To: Departments Concerned **Date:** November 14, 2019
From: Alan Stephenson
Planning & Development Department Director
Subject: **P.H.O. APPLICATION NO. Z-97-02-7** – Notice of Pending Actions by the **Planning Hearing Officer**

APPLICATION NO: PHO-1-19--Z-97-02-7

Request For: Stipulation Modification

RE: KIVA # 19-2653, Zoning Case # Z-97-02-7
PHO Submittal Written Request

Sheet:
A1.0
 ARCHITECTURAL SITE
 PLAN

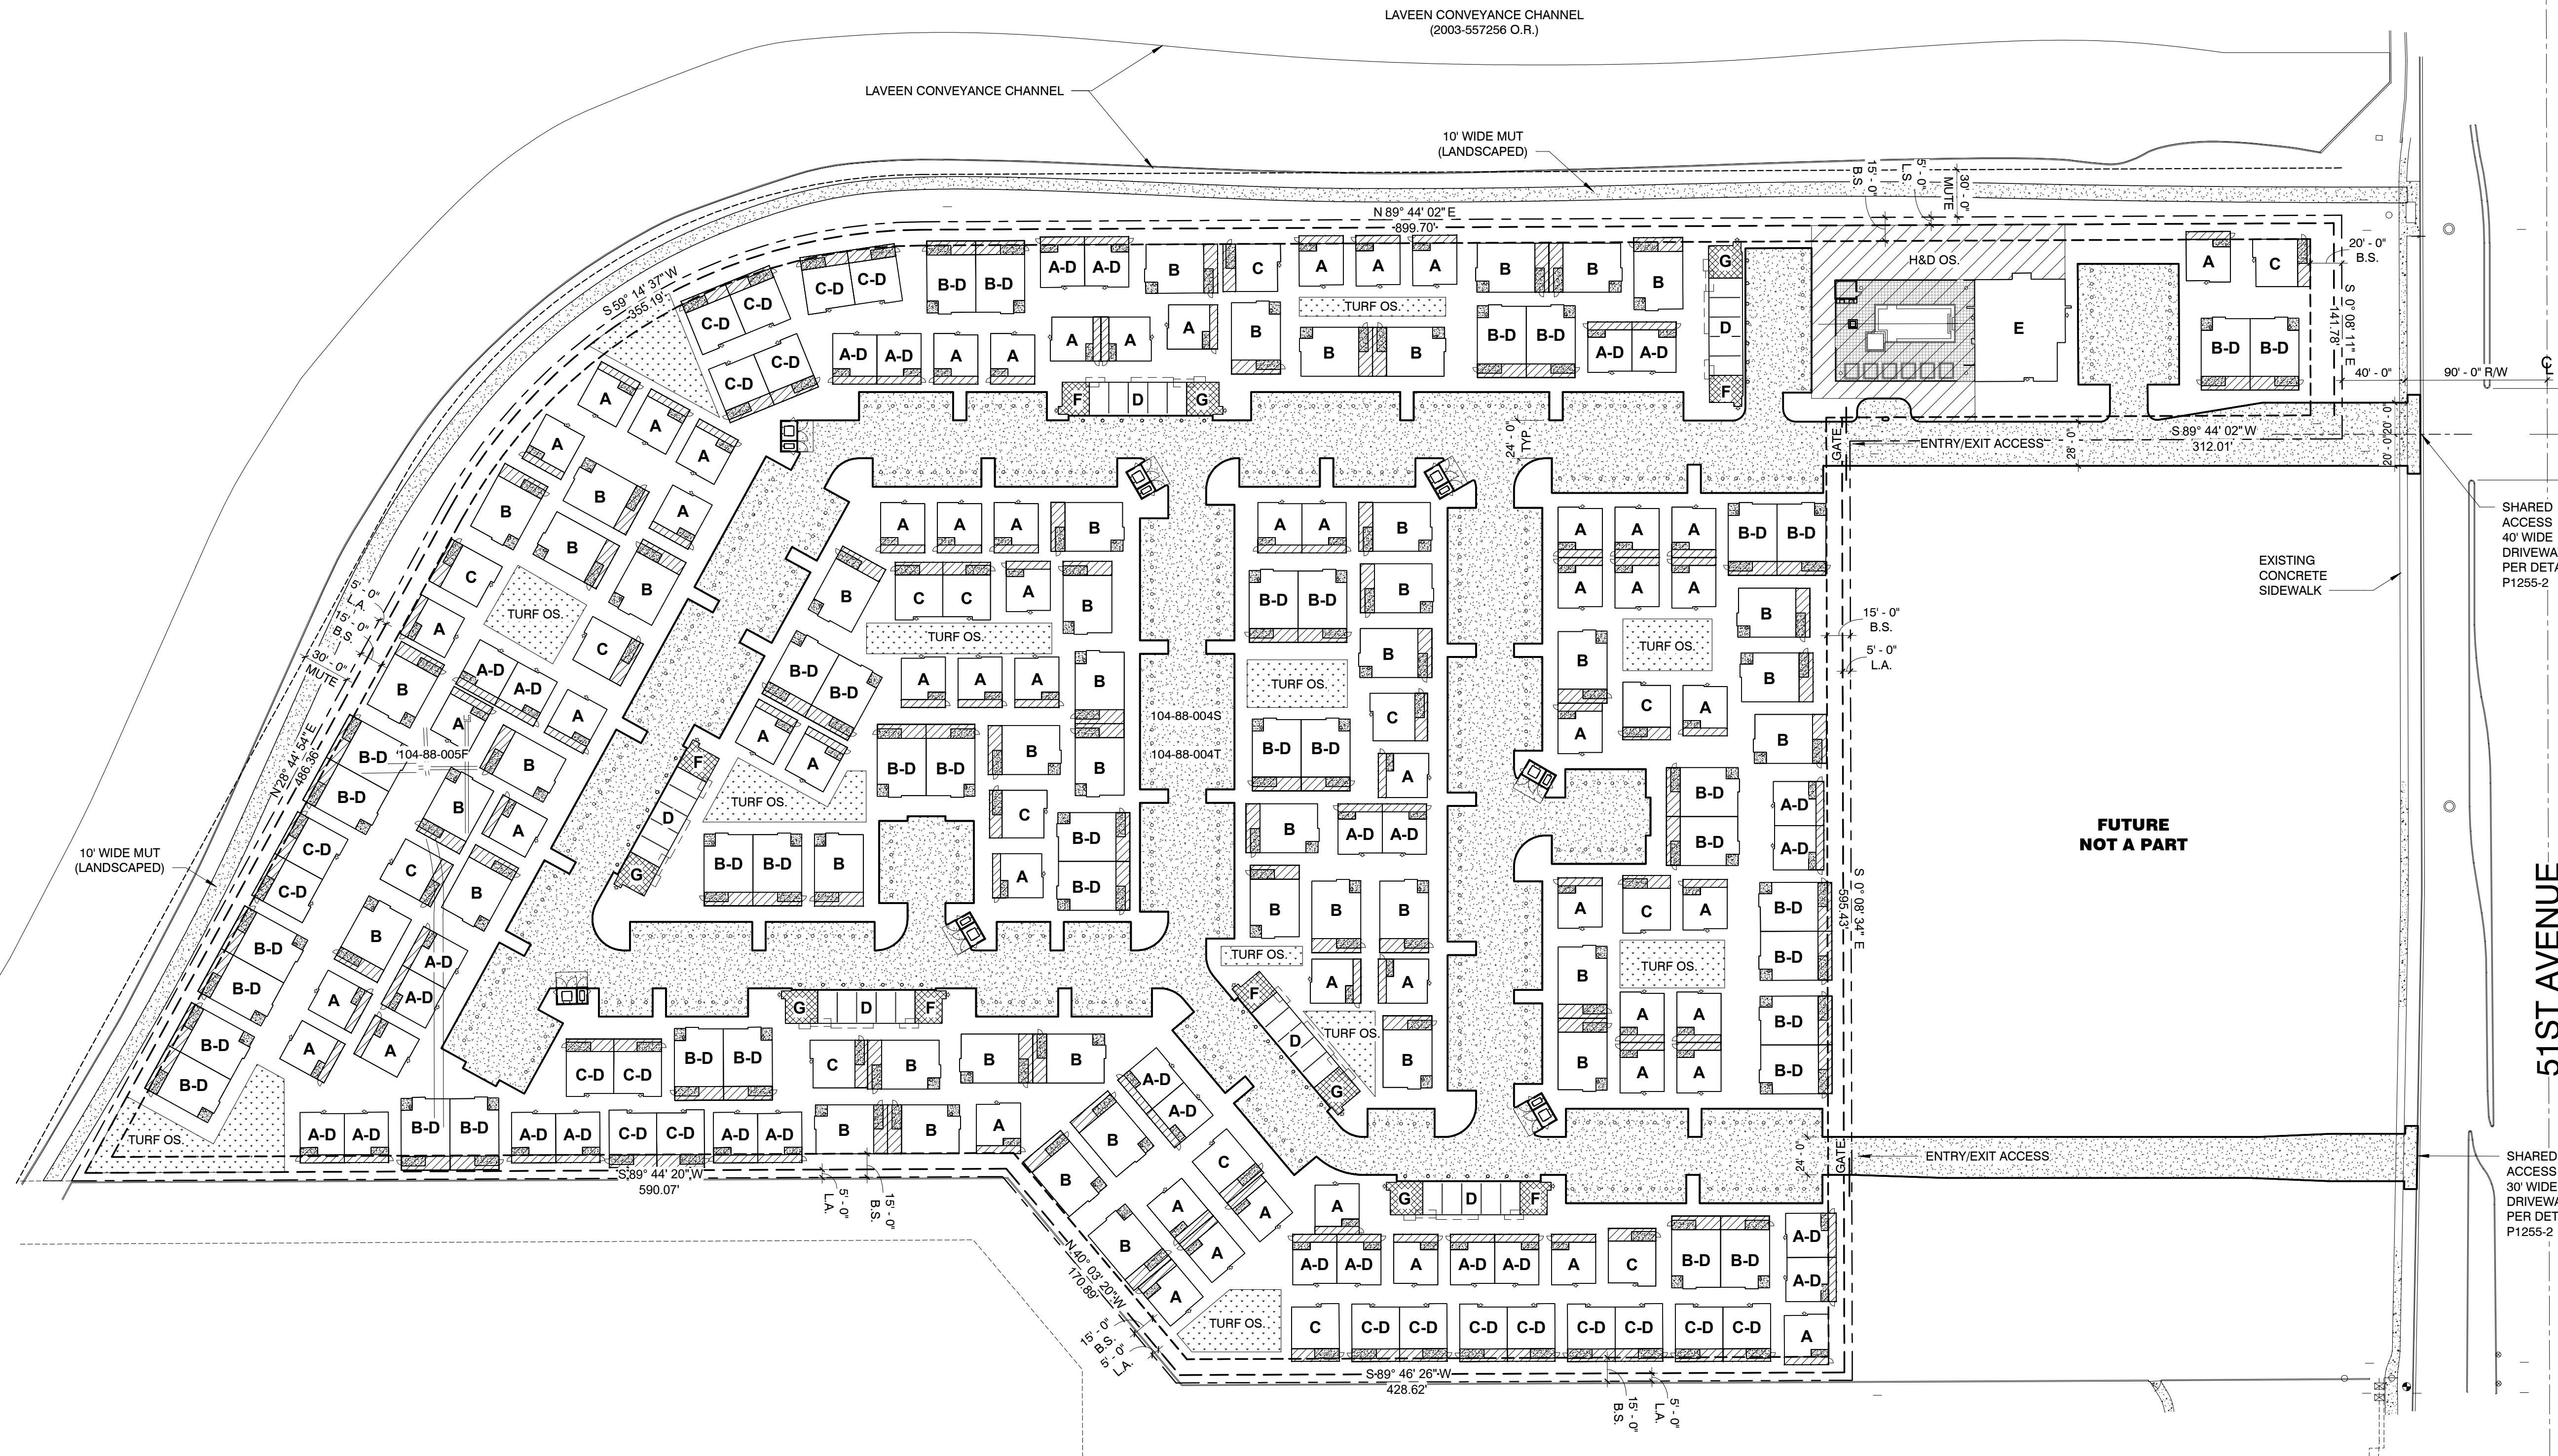
The first of our two requests is to alter stipulation number 1 from the original zoning case, Z-97-02-7, which states that the development shall be in general conformance with the site plan stamped August 14, 2002. Given that our density is drastically reduced and our product type is different, we will be asking for the stipulation to be modified to represent our current site plan for the proposed multi-family portion of the site, exclusive of any other portions of the site. The other item we are requesting relates to stipulation number 3 that states that prior to preliminary site plan approval for the multi-family site the elevations of the multi-family residential development be approved through the Planning Hearing Officer hearing process. We are not asking for a change to this stipulation but will be presenting the elevations in order to adhere to the stipulation. The requests are as follows:

Stipulation 1: That the development shall be in general conformance to the site plan date stamped August 14, 2002, as approved by Development Services Department WITH THE EXCEPTION OF PARCELS 104-88-005F AND 104-88-004T, WHICH ARE KNOWN AS THE MULTI-FAMILY PORTION OF THE OVERALL DEVELOPMENT. THE MULTI-FAMILY PORTION SHALL BE IN GENERAL CONFORMANCE WITH THE SITE PLAN DATE STAMPED NOVEMBER 1, 2019 WITH ALL OTHER CONDITIONS OF THE PRIOR ZONING CASE REMAINING IN EFFECT with specific regard to:

Rationale: The modification is requested due to our proposed development being of a far lesser density than the original site plan date stamped August 14, 2002; the development we're proposing is a single-family, mostly detached rental product.
